ENGINE - FUEL AND CONTROL - INTRODUCTION OF AN IMPROVED FUEL PUMP - CATEGORY CODE 6 -  
MOD.ENG-73-0068

# V2500-ENG-73-0068

NO. STS-73-002

ENGINE - FUEL AND CONTROL - MODIFICATION OF LP/HP FUEL PUMPS  
IMPELLER/INDUCER

Modification of Impeller/Inducer  
Figure 1

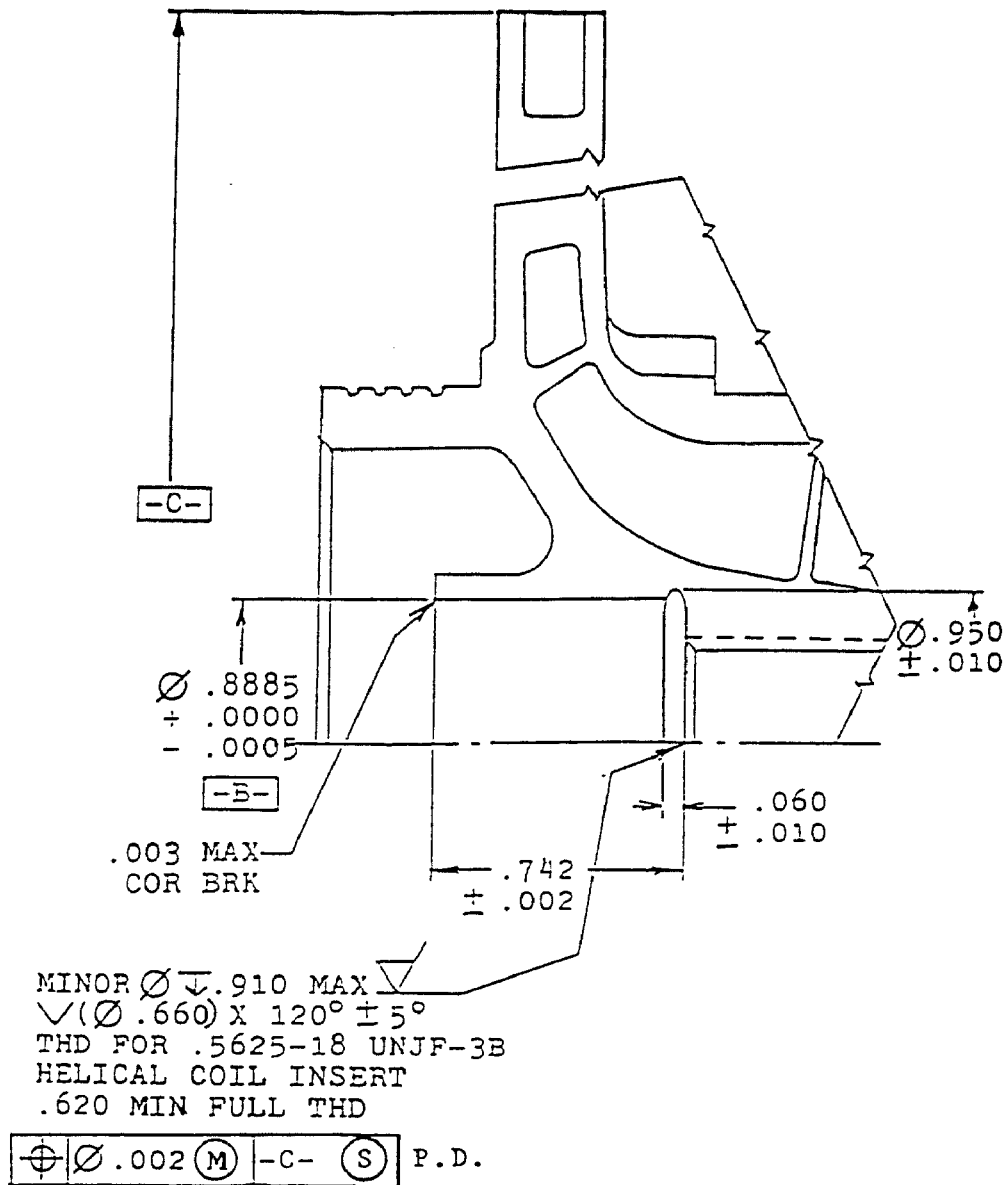
Modify the impeller/inducer (320, IPL Figure 1, 73-12-41; 340, IPL Figure 1, 73-18-41; 370, IPL Figure 1, 73-18-42). Refer to Figure 1 and 2 of this bulletin. If the impeller/inducer is damaged to the extent that modification is not possible, replace impeller/inducer with P/N 762726 (for pump assembly STS part number 5008735E, IAE P/N 5L0067) or 762725 (for pump assembly STS part numbers 5009913C, IAE P/N 5L0068 and STS part number 5010216D, IAE P/N 5L0069). Identify modified impeller/inducer according to paragraph 2.D. (1).

- (a) Machine impeller/inducer. (Refer to the Figure 1 of Modification of Impeller/Inducer.)
- (b) Perform local fluorescent penetrant inspection according to Sundstrand Standard Practices Manual, Bulletin 985, CHECK or Military Specification MIL-STD-6866.
- (c) Install helical coil (P/N MS21209F9-10) and spacer (P/N 762724).

- (d) Heat impeller/inducer and cool sleeve (P/N 762723) as required to obtain a temperature differential of at least 350 degrees Fahrenheit between the impeller and sleeve.
- (e) Install sleeve to bottom on spacer. Allow impeller/inducer to cool to room temperature.
- (f) Peen impeller/inducer on surface - D - of Figure 2 of Modification of Impeller/Inducer in four places to retain sleeve.
- (g) Finish machine impeller/inducer according to Figure 2.
- (h) Clean according to Sundstrand Standard Practices Manual, Bulletin 985, CLEANING or Cleaning instruction of the appropriate STS CMM (73-12-41 or 73-18-41 or 73-18-42).
